**LAND USE DEVELOPMENT ROAD SAFETY AUDIT (THEMATIC)  
OF**

**PROPOSED RESIDENTIAL AGED CARE FACILITY**

**AT 11-15 LANG ROAD, 76-80 MARSH PARADE, 536-542 HUME HIGHWAY, CASULA**

**Document reference:** 18142.02FA

## ANNEXURE D: NON-COMPLIANT DRIVEWAY LOCATIONS

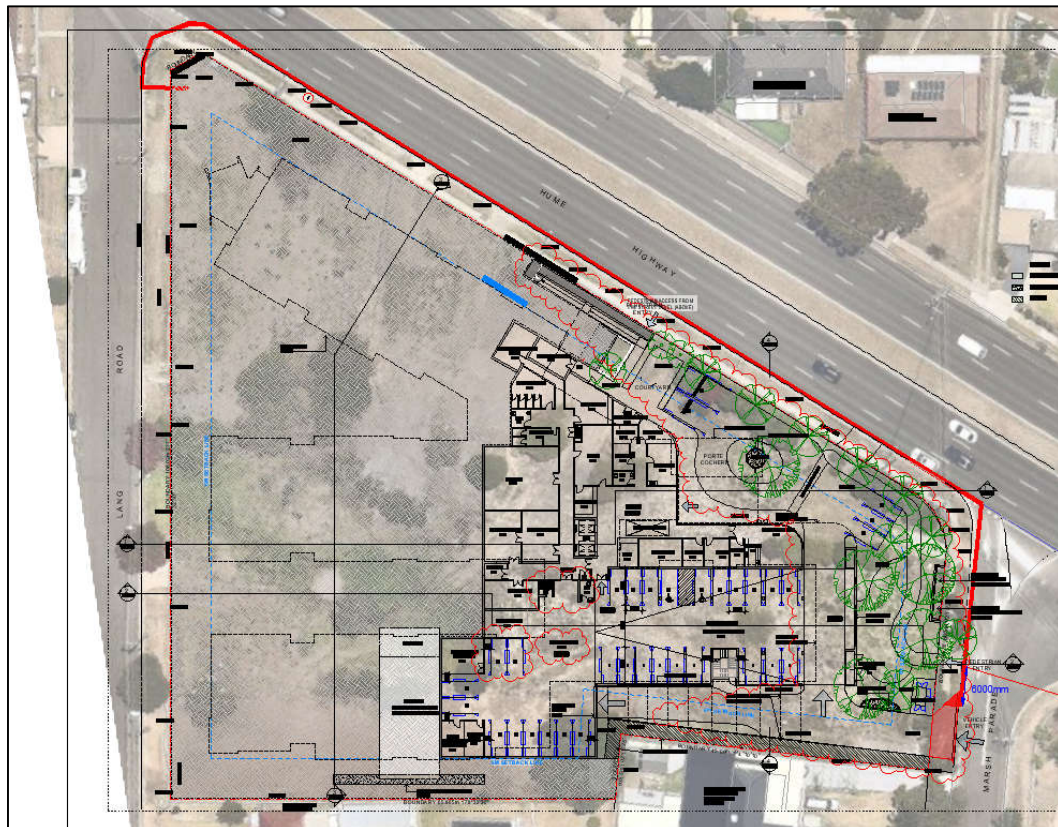
1. The proposed vehicular access (including proposed driveway splays) is located within prohibited driveway locations, with reference to *Clause 3.2.3 & Figure 3.1* of AS2890.1-2004. Refer to **Annexure D** for an illustration of non-compliant driveway locations.

## ANNEXURE E: CONCEPT DRIVEWAY AND SITE LAYOUT PLAN

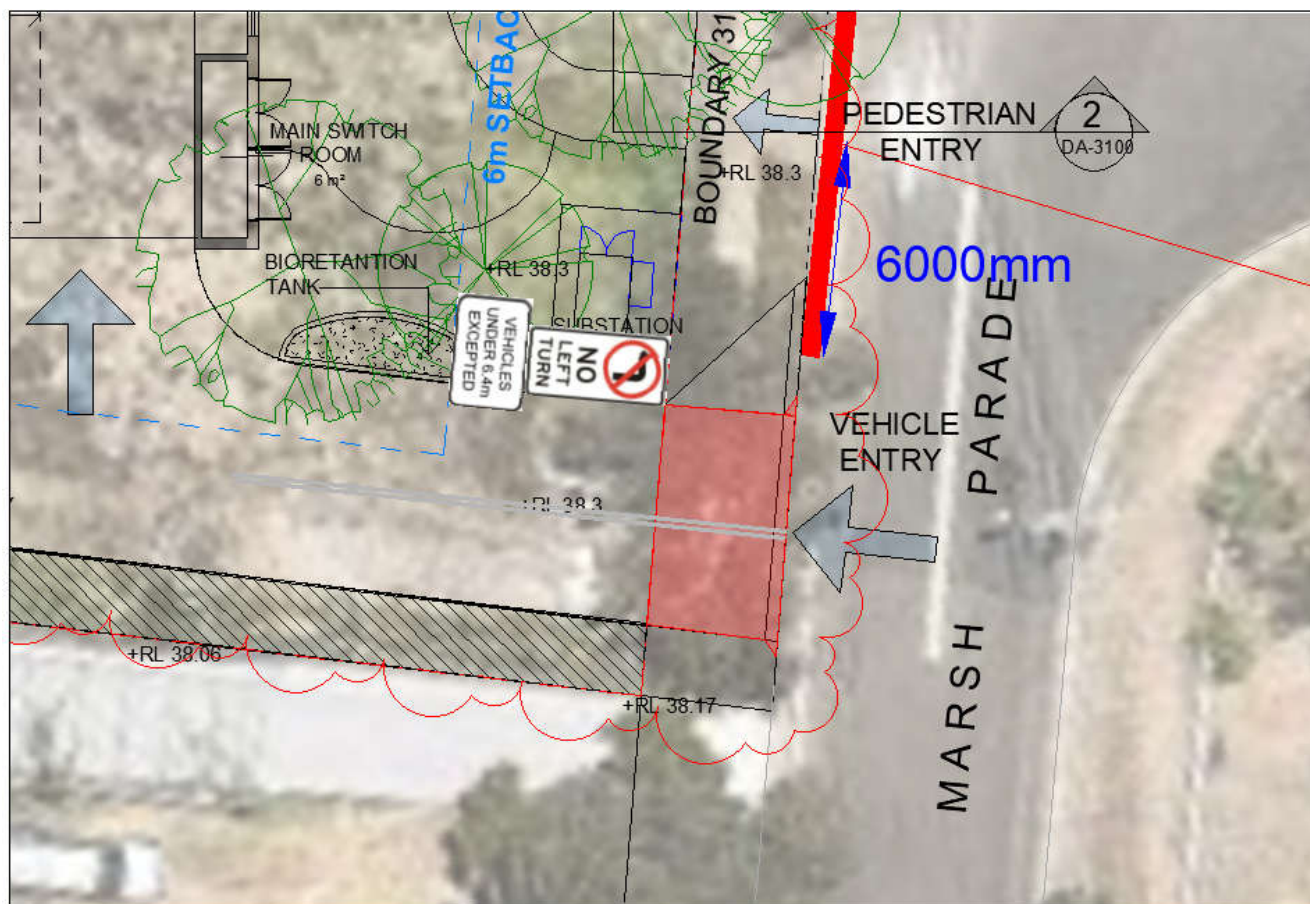
Key:  Non-compliant driveway location  
 Concept driveway shaded red, splay for MRV left entry still requires detailing.

- Modify / reduce the proposed driveway splay to accommodate left turn exit movements for vehicles up to a 6.4m SRV as per Clause 2.2 (a) of AS2890.2. The modification shall reduce the splay such that the driveway does not encroach into the prohibited driveway locations as per Clause 3.2.3 & Figure 3.1 of AS2890.1. It is expected that deliveries to the proposed development are occasional in nature, therefore service vehicles are capable of using the full width of the access driveway as per Clause 3.2.2 (d) of AS2890.2;

- A concept driveway and signage layout plan is shown in **Annexure E** for reference.
  2. Relocate site driveway to Lang Road
    - Approximately 95m of road frontage suitable for an access driveway to be located;

## ANNEXURE E: CONCEPT DRIVEWAY AND SITE LAYOUT PLAN

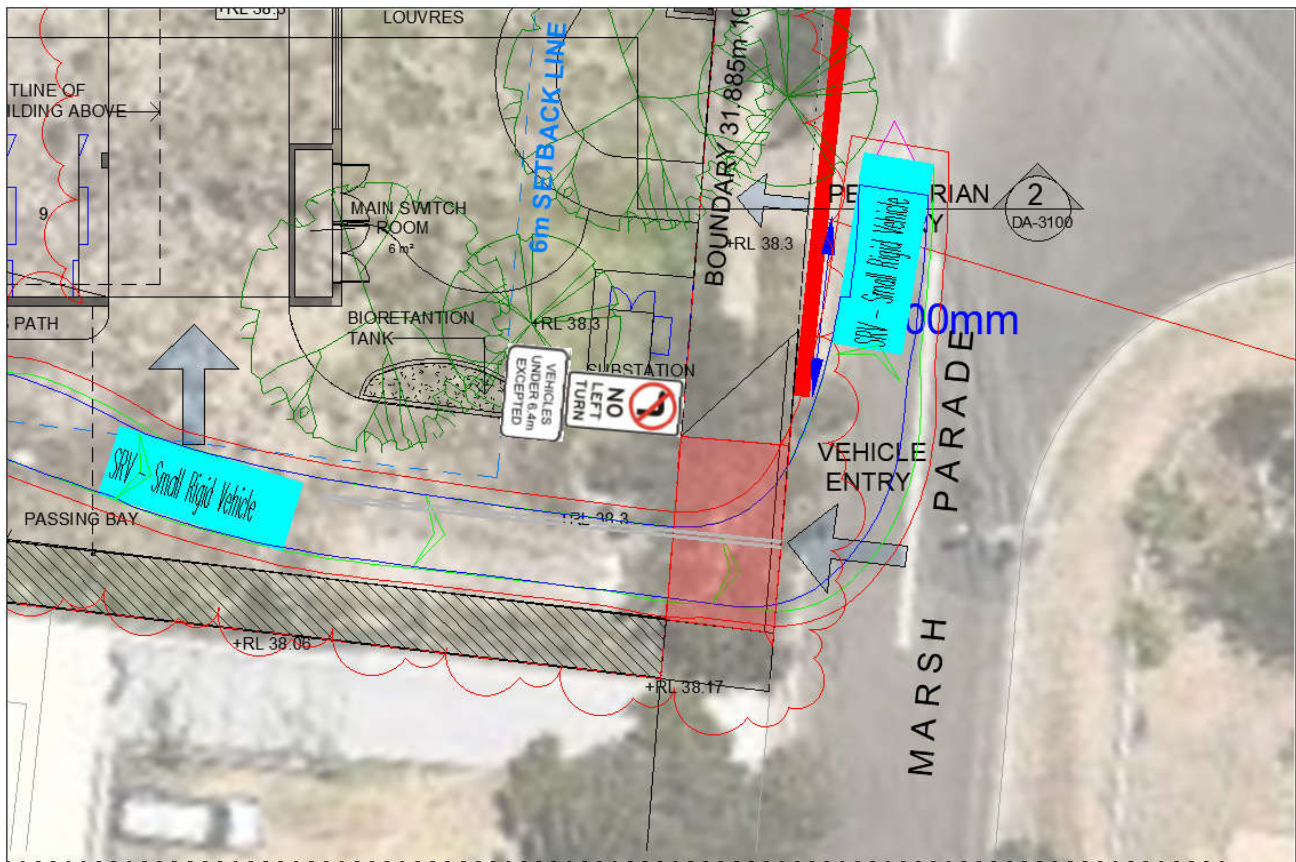
2. The swept path tests drawn by CBRK Pty Ltd dated 8 June 2018 show the MRV left turn onto Marsh Parade from the site driveway passes over the BB centre lines. An MRV passing over the centre line of the road has the potential to cause vehicle conflicts between the exiting vehicle and a vehicle traveling eastbound along Marsh Parade, resulting in potential side swipe or head on collisions.

**SRV LEFT turn from site driveway onto Marsh Parade**

**Tested @ 5km/h**

**Successful**
